INNER WEST COUNCIL

SECTION 82 ASSESSMENT REPORT

Application No	10.2016.280
Address	22 Yasmar Avenue, HABERFIELD NSW 2045
Proposal	<p>This Application seeks a review of Council's Determination 10.2016.280.1 dated 28 February 2017, which approved Alterations and Additions to a Dwelling House.</p> <p>The Review seeks to:-</p> <ul style="list-style-type: none"> • Amend Condition B(1)(a) (western side setback of the new addition) so as to permit a setback on the western boundary between zero to a maximum of 200mm, and • Delete Condition B(1) (d) (degree of slope of the new rear hipped roof plane)
Date of Lodgement	20 April 2017
Applicant	Seeman Rush Architects
Owner	Ms Sarah Elliot & Mr Malcolm Noble
Number of submissions	Three (3) objections
Building Classification	1a
Reason for determination at Planning Panel	Recommendation is substantially the same as the Development Application
Main Issues	Heritage
Recommendation	Confirm the Original Determination

1 ATTIC FLOOR PLAN

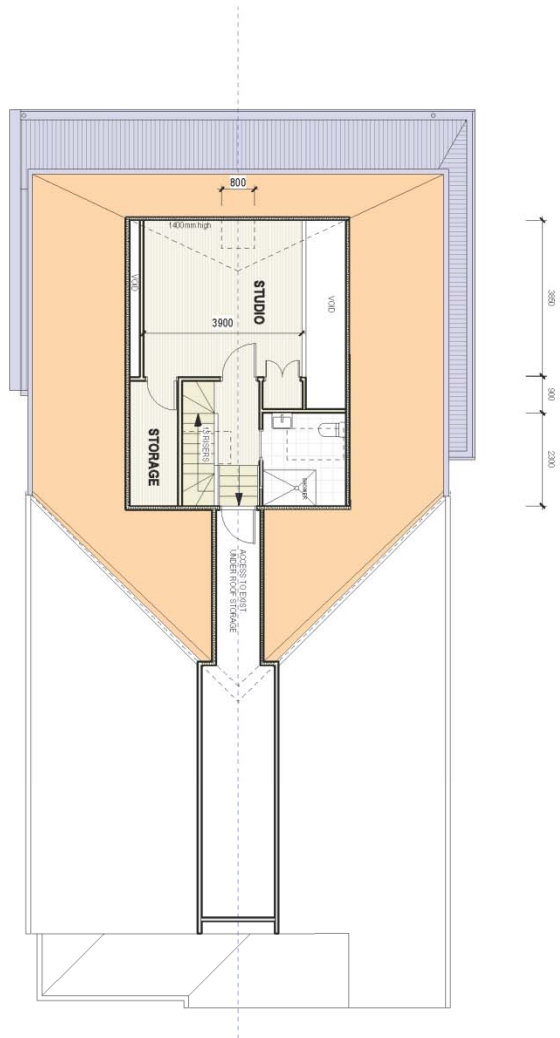
The implication of Condition B1(d), to lower the pitch of the back roof plane to 19.8 degrees, is that the habitable area of the attic (minimum 2.2m for an attic room) is reduced by more than 50% to an area 1.5m x 0.7m. Attachment B1 and B2 shows the impact of this condition on the relevant Section and Attic Floor Plan. The attic area is no longer a habitable space and the current plans are completely redundant.

2 NORTH EAST ELEVATION

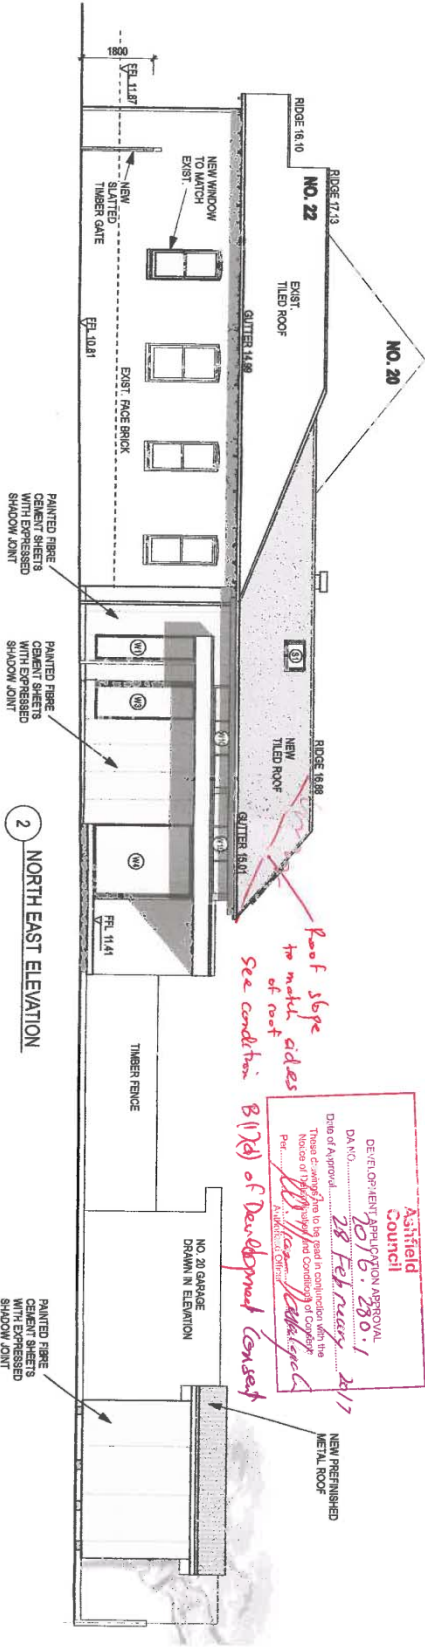
Roof slope to match sides of roof
 See condition 8 (1) of Development Consent
 Date of Approval: 28 Feb 2017
 DA No: 2016.280.1
 Project: 22 Yarrar Avenue, Haberfield
 Title: Alterations & Additions
 Preparer: [Signature]
 Drawn: [Signature]
